A
TRANSNUCLEAR
AN AREVA COMPANY

Subject: Revision 5 to Application for Amendment 1 to TN-68 CoC 1027
Docket 72-1027, TAC L23802

Transnuclear, Inc. herewith submits Revision 5 to its application for Amendment 1 to TN-68 CoC 72-1027. Based on recent discussions with the NRC staff, this revision makes changes Updated Final Safety Analysis Report chapters 4 and 9 to regarding TN-68 cask thermal view factors, and neutron absorber testing, respectively.

Figure 4.10-2
Finite Element Model for Radiosity Methodology

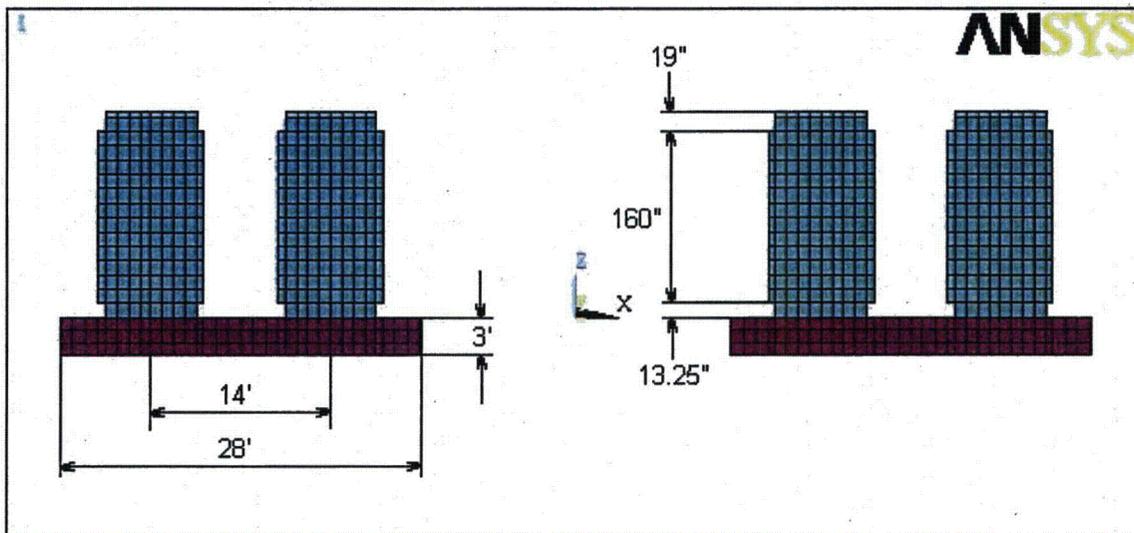
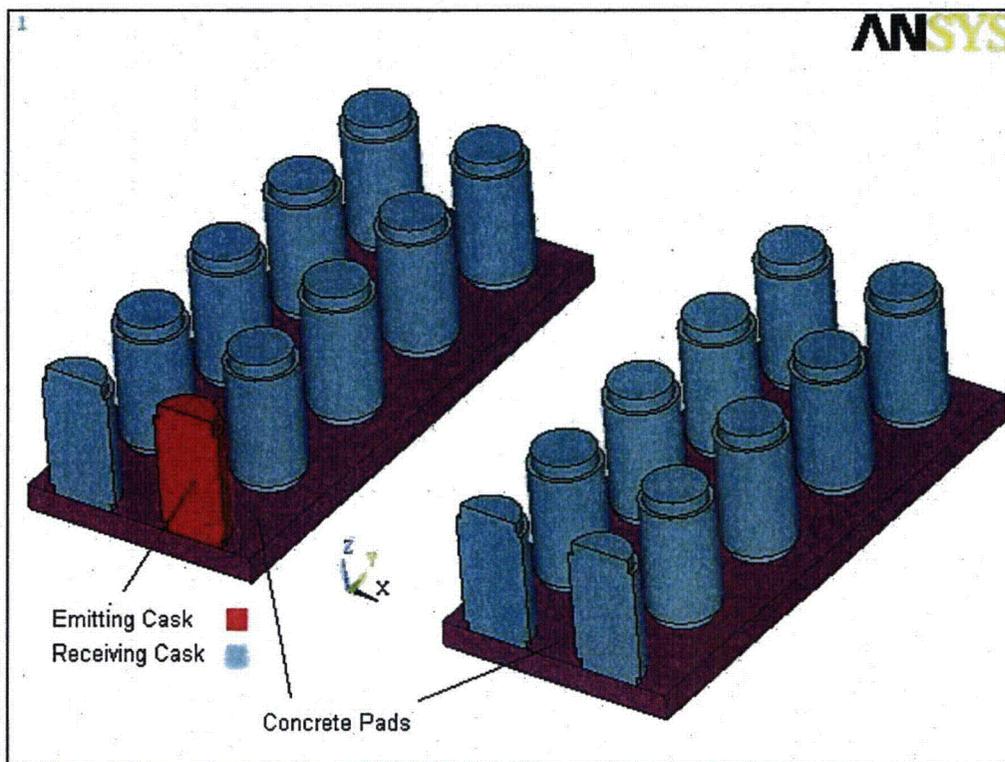
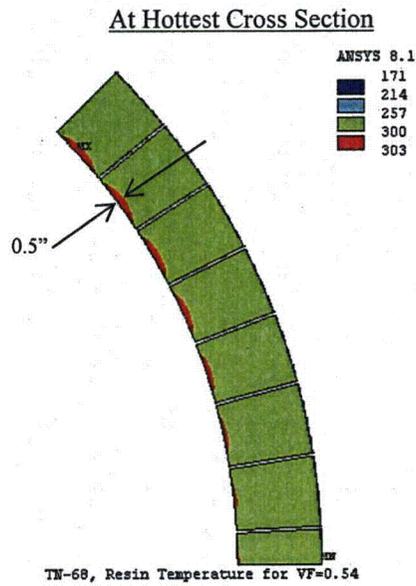
- Page annotated "Intentionally Blank" (back side of page 4.11-1)
- Figure 4.10-2, Rev 5, new figure referenced from new Section 4.10.1.1
- The back of Figure 4.10-2 is blank and not annotated, per the previous convention.

A finite element model of the two $2 \times \infty$ storage arrays of TN-68 cask is created using ANSYS compute code [12]. This model considers half of the emitting cask and is extended to four complete casks stored in the two $2 \times \infty$ storage arrays. This model is illustrated in Figure 4.10-2.

The view factors from the emitting cask to the other casks ($F_{e,casks}$) and to the concrete pads ($F_{e,concrete}$) are calculated using the radiosity solver method in ANSYS [12]. The view factor of the emitting cask to ambient ($F_{e,\infty}$) is calculated by subtracting the above view factors from 1.

Figure 4.10-3
Temperature Distribution of Radial Neutron Shield Resin for Case # 4

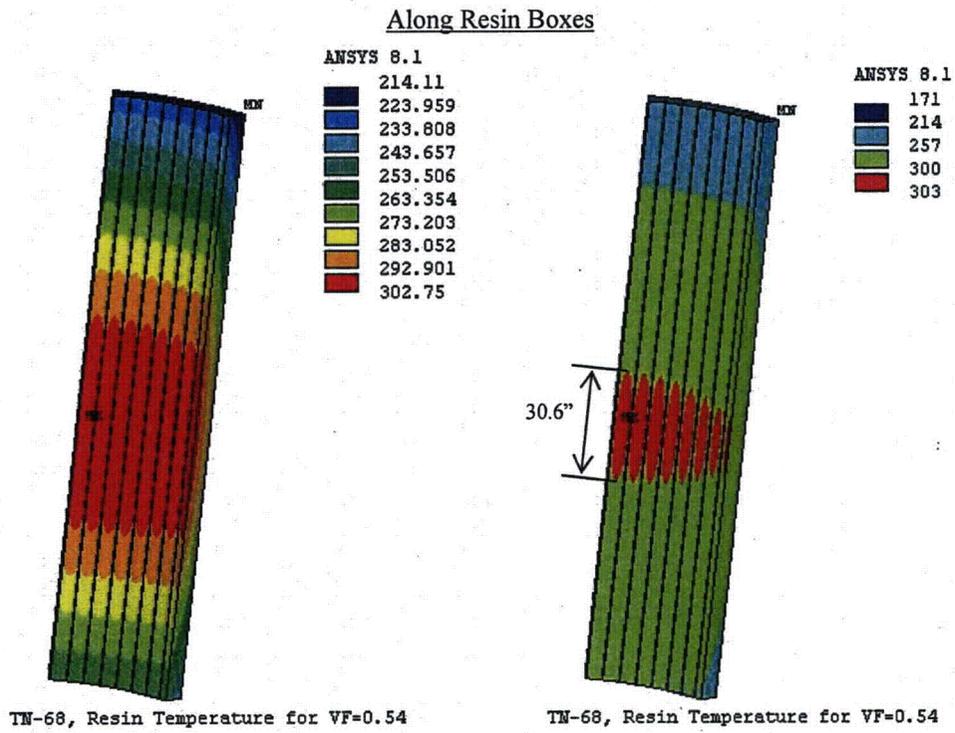
- Figure 4.10-3, Rev 5, new figure referenced from new Section 4.10.1.1
- The back of Figure 4.10-3 is blank and not annotated, per the previous convention.

As seen in Table 4.10-3, only the maximum temperature of the radial neutron shield (resin) exceeds the limit for the lowest view factor (case # 4). The average resin temperature at the hottest cross section is 287°F. This temperature is below the 300°F limit. Temperature distributions for the radial neutron shield are shown in Figure 4.10-3 for case # 4.
